### **ADDITIONAL RFI – RESPONSE 11/05/2016**

**Iron Gates Residential Subdivision – Response to Richmond Valley Council Request for Further Information**

**A0002-AA007094-AAL-01**

Figure 4- Typical Infiltration Strategy

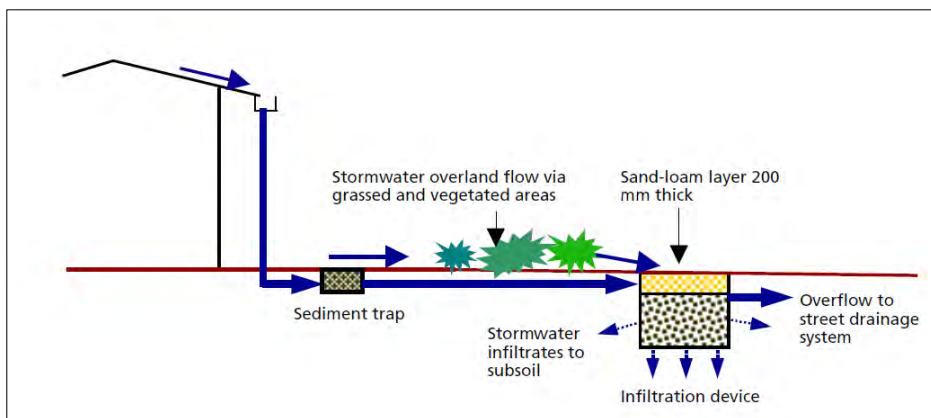
5. Section 7.2.3 Infiltration pits are 1m deep and almost 5m<sup>2</sup>. Council has concerns;
- What are the risks to a saturated sub base for the roads?

- Impact to/from driveways?  
Driveways will be coordinated during detailed design to avoid clashes with drainage system.
- How is overflow from the pits to be managed without causing nuisance stormwater flows to adjoining land owners. Council preference is for the overflow to be discharged to street kerb or via Internal Allotment Drainage (IAD).

To avoid any risks of saturating road sub-base, all roads will be provided with subsurface drainage in accordance with The Northern River Council Specs.

Flows will be captured and conveyed to the infiltration system, with overflow being directed to the street kerb system. Refer figures 4 and 5 below shows a typical infiltration system details. It should also be noted that all proposed lots typically fall to the road with no inter allotment needed.

Figure 5- Infiltration System Details

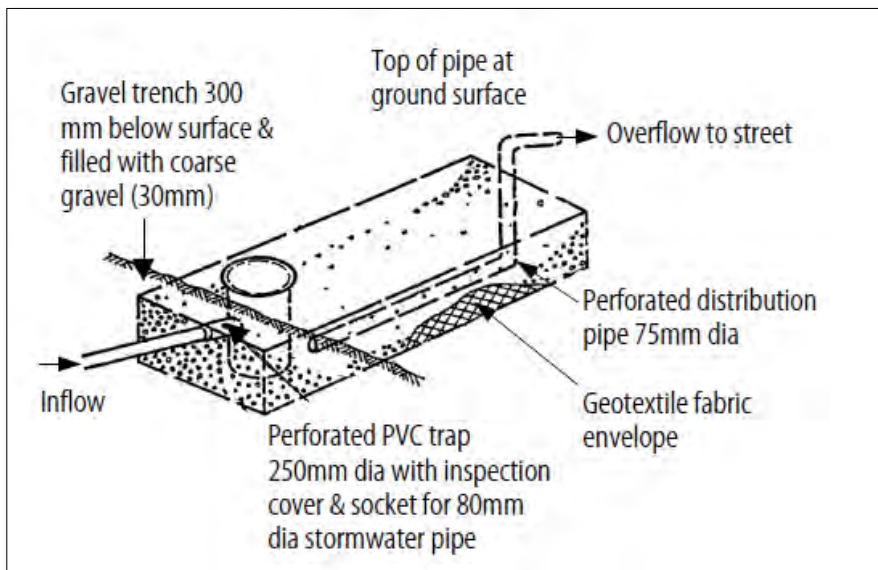
- How are the pits be protected from future owners constructing over the pits or reducing the effectiveness of the pit. An easement on title may be an appropriate method to protect this infrastructure.

An easement for Stormwater will be provided over each device. This will be detailed during the detailed design phase of the project.

Figure 5: Woodburn Street / Wattle Street Intersection

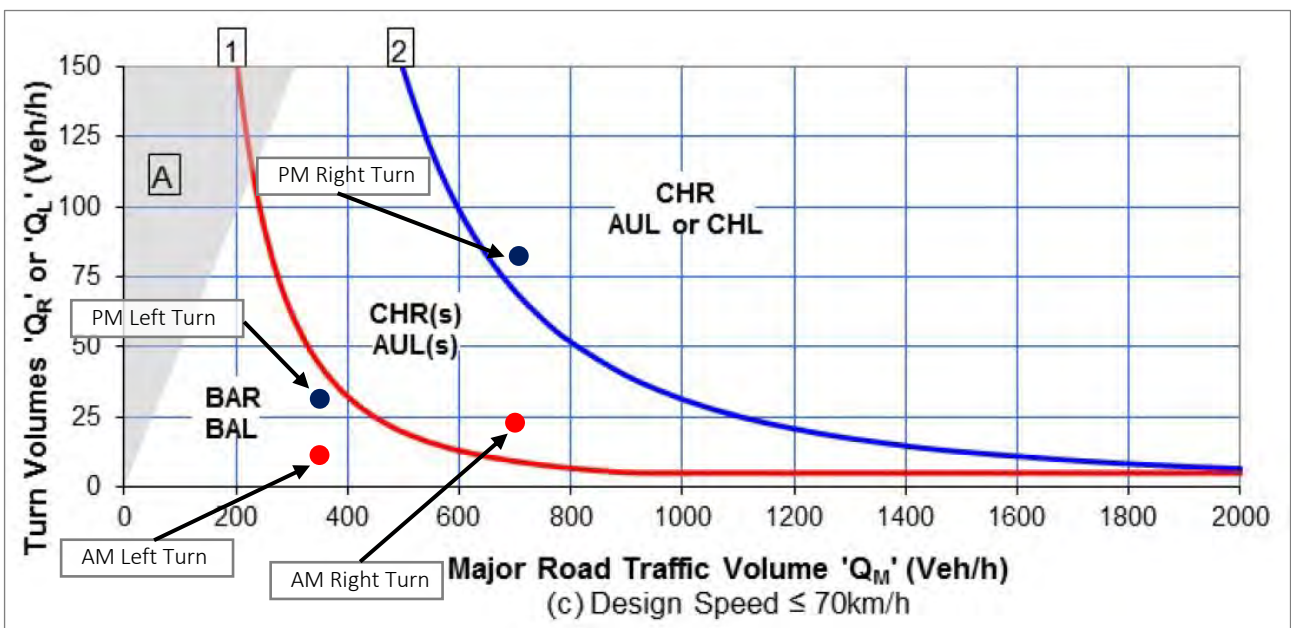
*The weight of loads on the bridge is unknown and should be to ensure bushfire tenders can safely cross it and that it has the capacity to provide for the traffic generated by the DA, in particular the impact of transport haulage associated with the bulk earthworks.*

As it is likely that there would be additional right turning traffic due to existing surrounding uses. TTM considers that a suitable right turn treatment would be a Channelised Right Turn (CHR).

TTM recommends that a CHR and a BAL turning treatment be incorporated into the design of the Woodburn Street / Wattle Street intersection. TTM has prepared a functional layout plan which demonstrates the recommended turning treatments, as shown enclosed. TTM expects that the turning treatments should be able to be completed with linemarking and recommends that it is implemented before the completion of the development.
